**Indiana State University Federal Credit Union – Addition: A20-016**

September 7, 2021

**Addendum #1**

ASPHALT SHINGLES ON 15# ROOFING FELTS ON 1/2" O.S.B. DECK W/ "H"-CLIPS ON WD. TRUSSED@24" O.C.

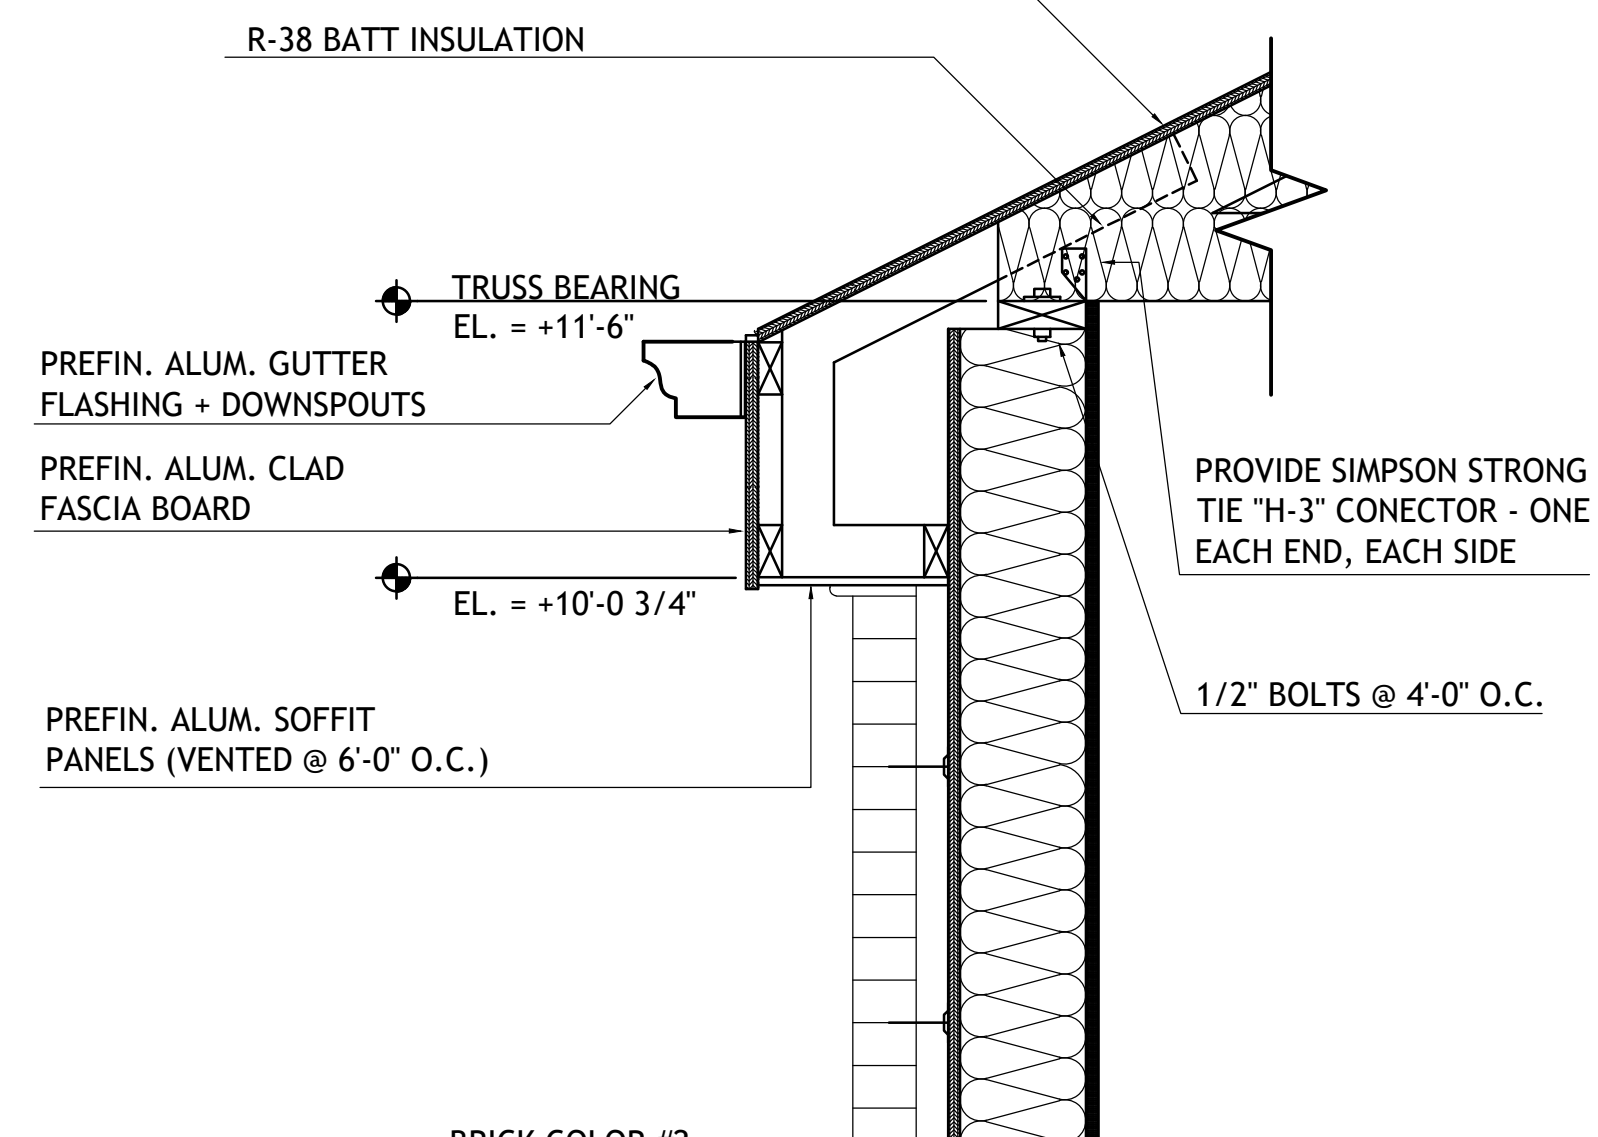
1. Replace sheet with attached sheet affixed with revision note '1 – Addendum 1 – 09.07.2021'
2. Sections revised
